WHITE BAY 6 MARINE PARK

Response to Submissions Modification 5 to MP06_0037

Prepared for White Bay 6 Pty Ltd | 15 May 2018

Report J13129RP2 | Prepared for White Bay 6 Marine Park | 15 May 2018

Figure 3.3 Extract of Glebe Island and White Bay Master Plan figures

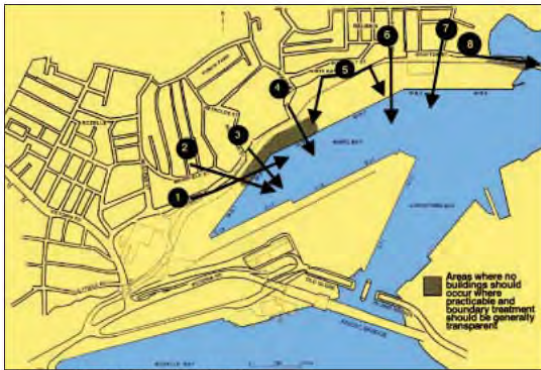
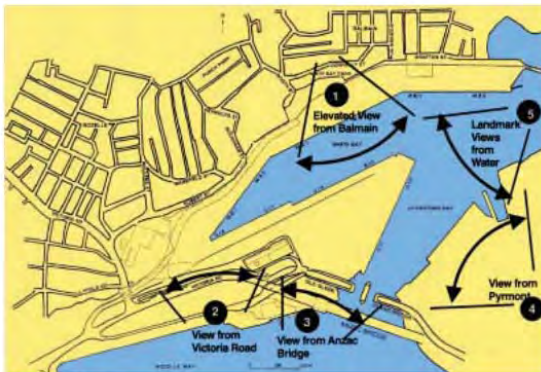
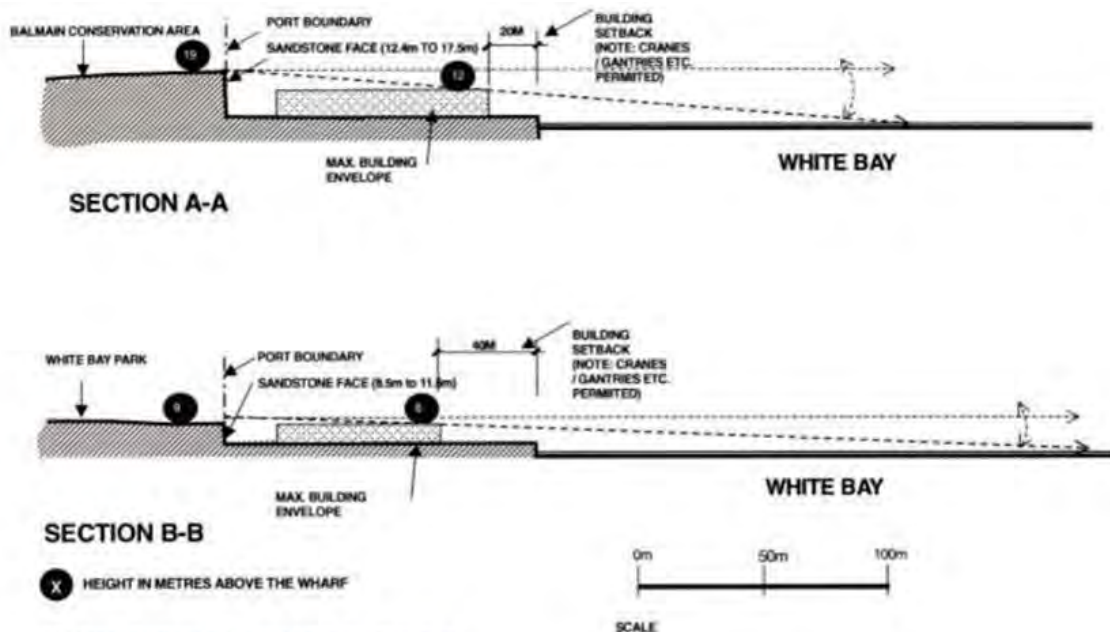
- Provide justification for the location of workshop 5 within the 20 m setback from the foreshore as required by the Glebe Island and White Bay Master Plan.

Relevant Figures are extracted in Figure 3.3 and Figure 3.4. For reference, Building 5 is proposed to be a 3.2 m tall structure with a 70 m² footprint.

As shown in the master plan figures 7 and 18, the intent of the setback is to ensure that view corridors and street vistas are preserved. Larger buildings commonly associated with area (eg buildings similar to Building 1, Building 2 and the cruise terminal) are envisioned to be set back to allow for the elevated areas of Balmain to limit the obstruction of views to the water. This is best demonstrated by Section A-A of figure 18 that show how a 12 m tall building would allow for a view to the water from a raised perspective. Smaller buildings, such as Building 5, do not appear to be considered in the same way.

The master plan allows for obstructions within the setback area in the form of containers, generally 5 m tall (three containers). As such, the master plan envisions that the setback area would have small obstructions behind the larger buildings set further away from the foreshore. It is noted that a standard container has a height of approximately 2.6 m and a footprint of approximately 30 m², meaning Building 5's scale is approximately the same as two containers, side by side. This impact is substantially less than that permitted by the master plan.

The master plan figure 7 also appears to acknowledge that buildings could be permitted within the setback area. This is evidenced by the dark grey area extending eastward from point 8, being the Grafton Street viewpoint. The shading denotes an area 'where no buildings should occur where practicable and bound treatment should be generally transparent'. Building 5 is to the south of this view corridor, and as such, is in an area that is not envisioned to have no buildings. It is also noted that Building 5 would have no impacts on the landmarks shown in master plan figure 8 or vista panoramas in master plan figure 9.
